DRI 751
Vineyard
Montessori
School
Expansion

DRI 751 Revised Building Plans

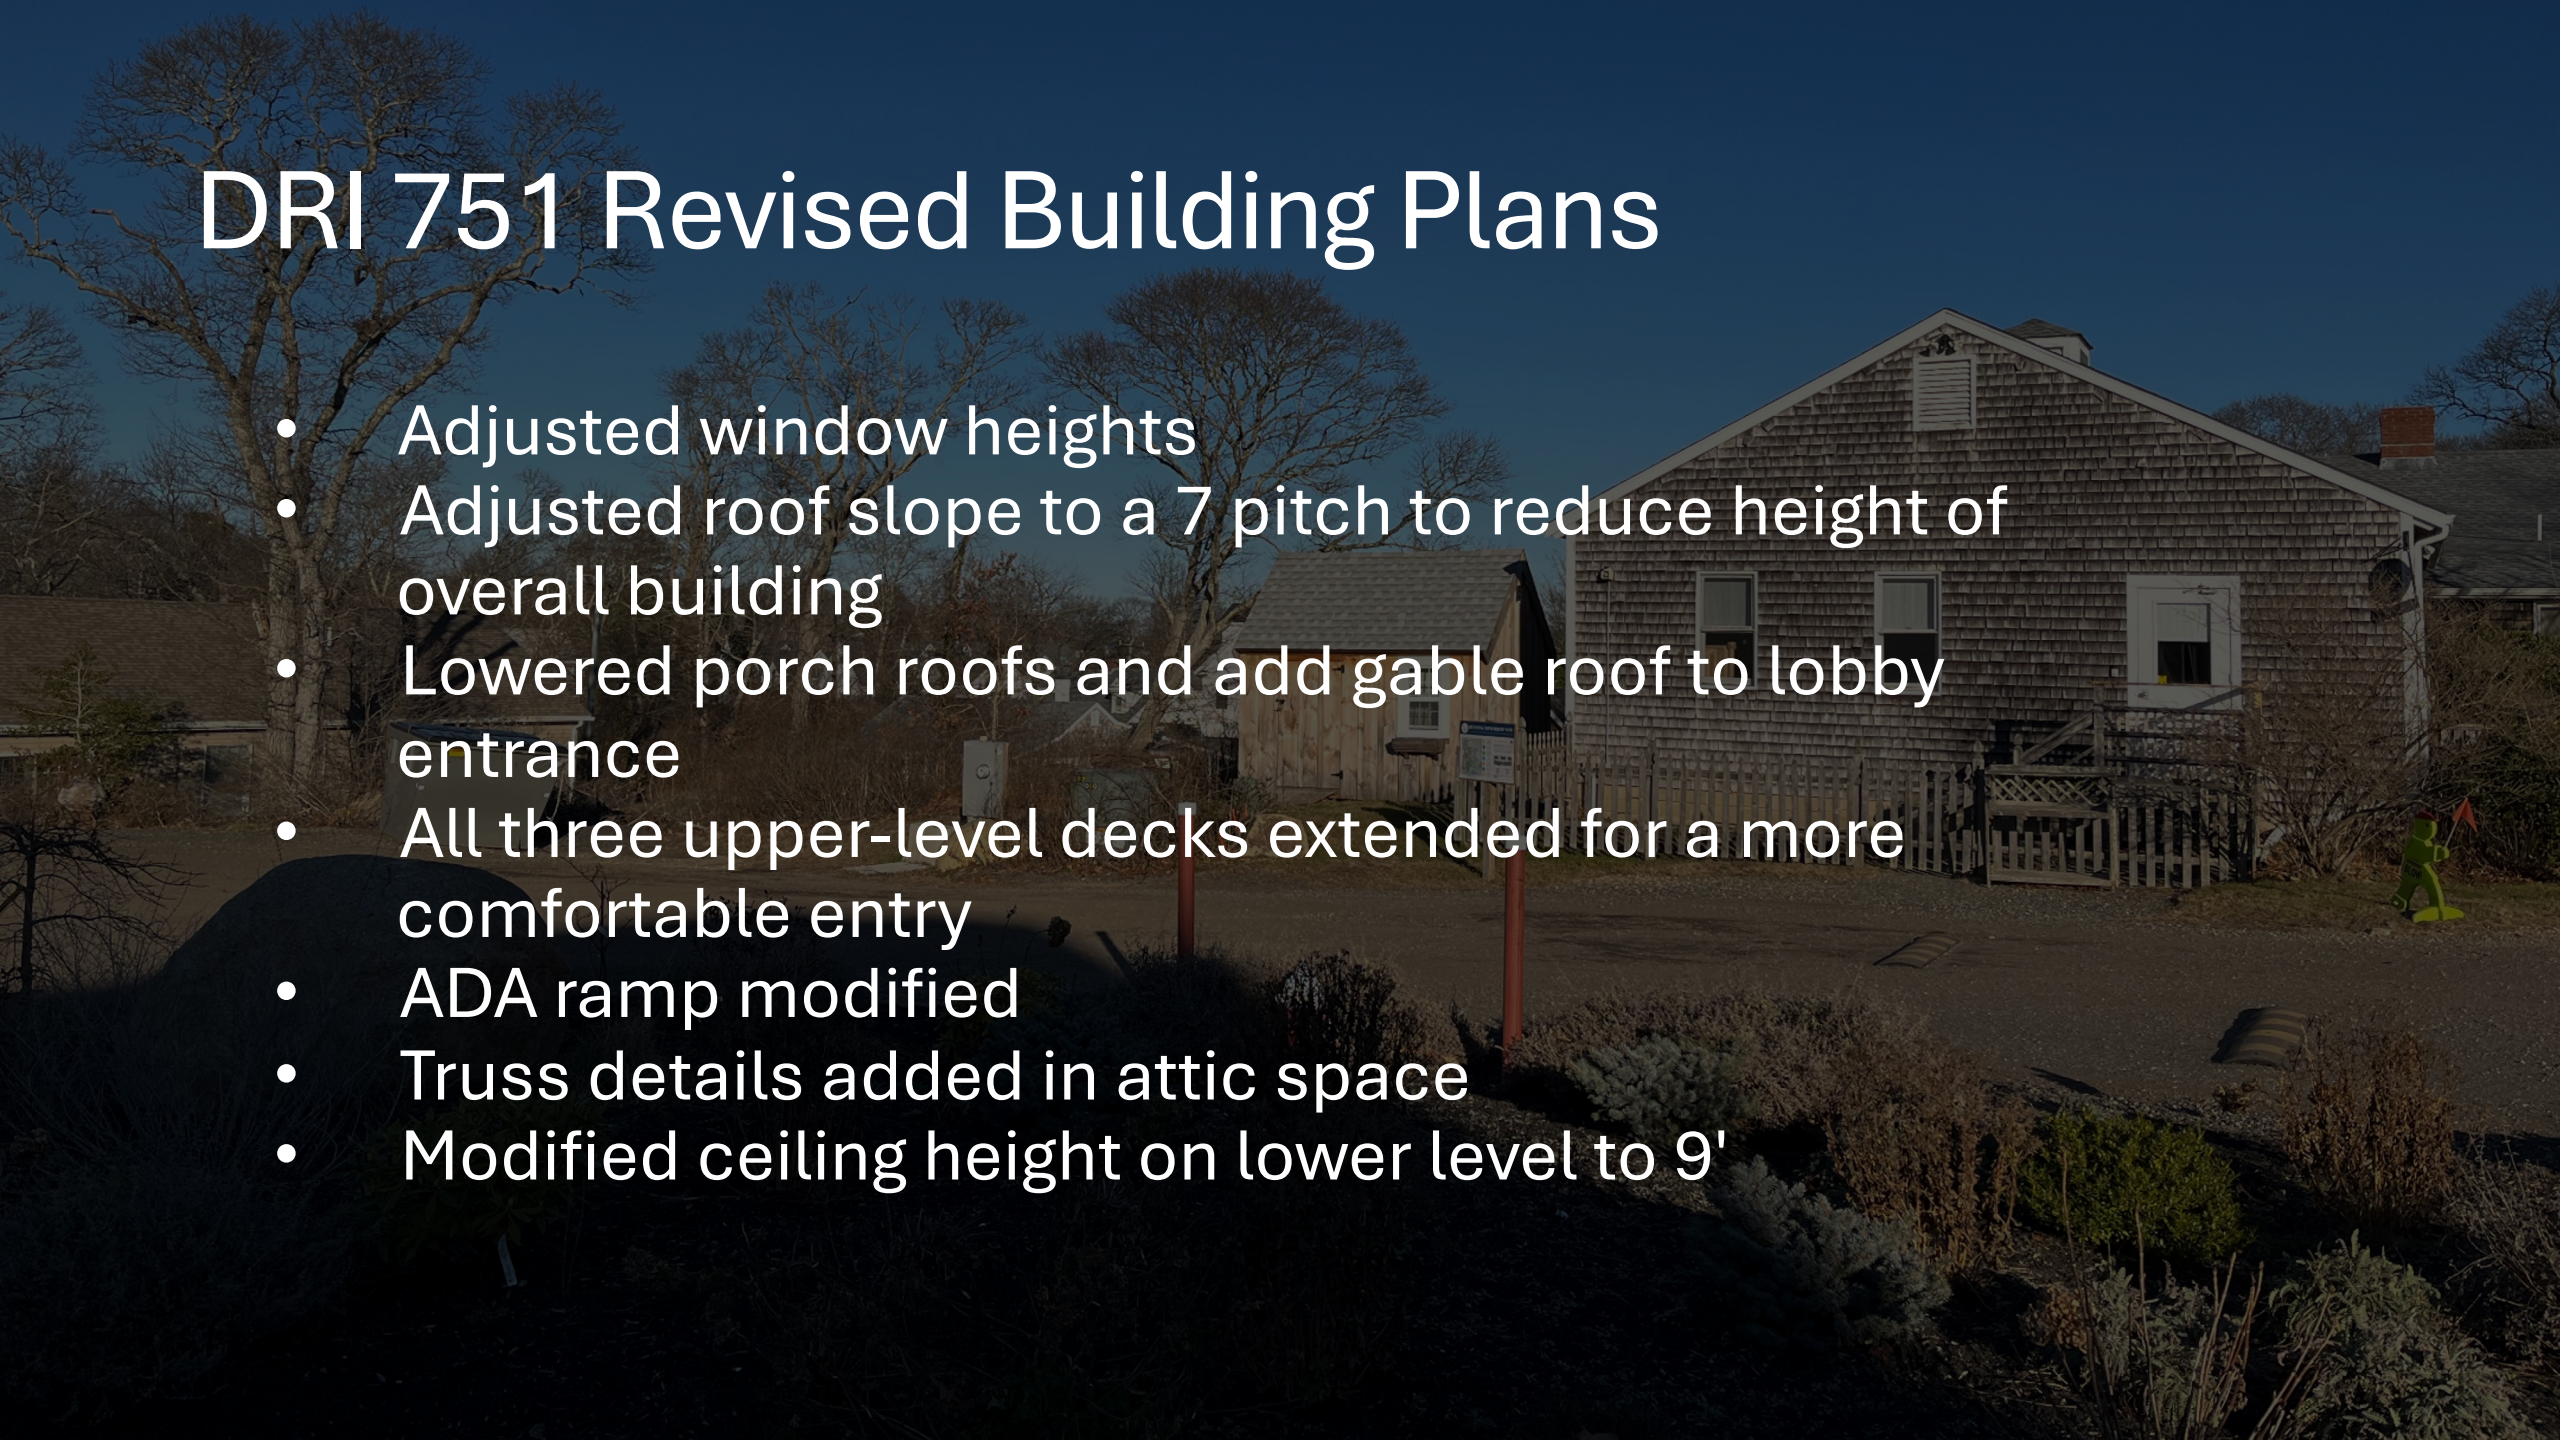
- Adjusted window heights
- Adjusted roof slope to a 7 pitch to reduce height of overall building
- Lowered porch roofs and add gable roof to lobby entrance
- All three upper-level decks extended for a more comfortable entry
- ADA ramp modified
- Truss details added in attic space
- Modified ceiling height on lower level to 9'

- Ridge height lowered two feet, two inches
- Approximately 31 feet from lowest grade to ridge
- Approximately 24 feet from highest grade to ridge
- Average grade to ridge = 27 feet
